HDC-2022-00066**Address: 933 W. Pine Street****District: Old Allentown Historic District****Applicant: ANEP Investments LLC, Owner****Proposal: Legalize siding and vinyl windows; install garage door (Violation Correction)****Building Description:**

933 W. Pine Street after exterior alterations.
(Applicant)

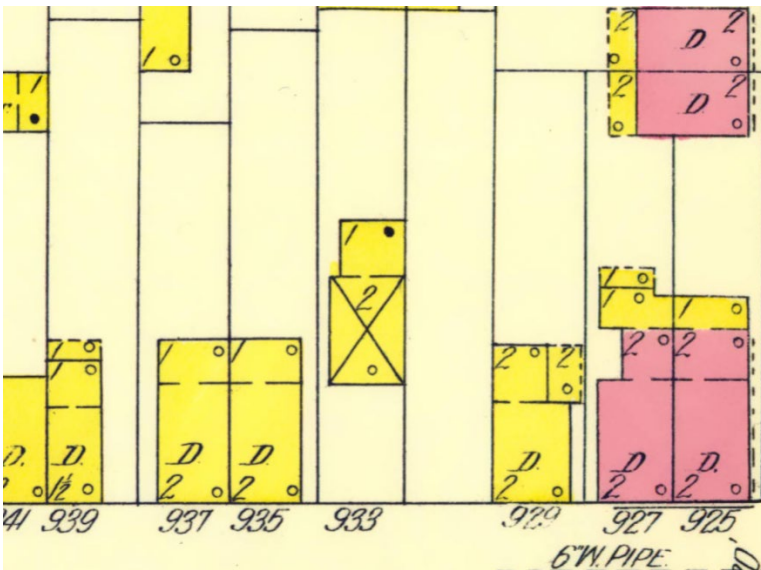
Staff questions whether the historic wood siding remains under the vinyl siding. The new cladding does not match the historic in material composition, size, profile, shape, pattern, or appearance and is not appropriate and does not comply

with Guidelines 3.2.5 and 3.2.6. The building historically had flush vertical boards. Staff recommends removing the vinyl siding and either exposing the original siding (if present) or installing new wood siding to match the historic.

Similarly, staff finds the second-story vinyl windows to be inappropriate in material composition, size, profile, appearance, and configuration. While the historic windows no longer remain, the age and function of the building suggest that the windows were likely wood six-over-six double-hung sash windows. Appropriate replacement windows should comply with Guideline 3.5.9. The photo prior to the exterior alterations shows that the windows did not have exterior trim, but did have a thin wood sill that should be replicated. The new vinyl windows do not comply with Guidelines 3.2.6 or 3.5.9.

Denial of the legalization of the vinyl windows and siding, pursuant to Chapter 3, Section 3.2 Wood Siding & Trim and Section 3.5 Windows. Approval of the removal of the first-story infill and installation of a new garage door, provided the following:

- the infill is carefully removed so as not to damage the historic framing;
- new wood trim is installed to match the historic trim; and
- the new door is wood and is either paneled or contains a crossbuck design.

933 W. Pine Street prior to exterior alterations, undated. (Applicant)

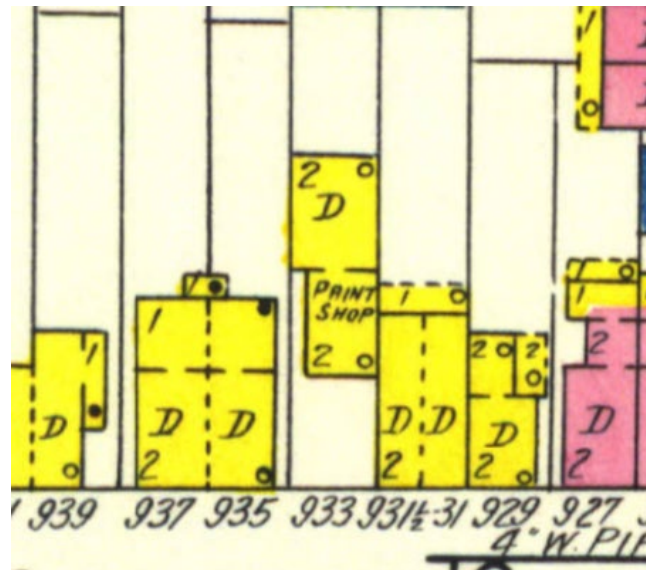
Staff supports the applicant's proposal to remove the infill from the first-story opening and reinstall a garage door. Staff finds the proposed metal door imitating paneled wood to be inappropriate per Guideline 3.6.9 and recommends a wood door with a paneled design consistent with the wood paneled door that existed prior to the alteration. A crossbuck design would also be historically appropriate for the building's era of construction. Staff also recommends installing simple wood trim to match the historic garage opening. Removing the infill would return the historic fenestration patterns and would comply with Guidelines 3.5.10 and 3.5.11. However, the proposed garage door does not comply with design guidelines.
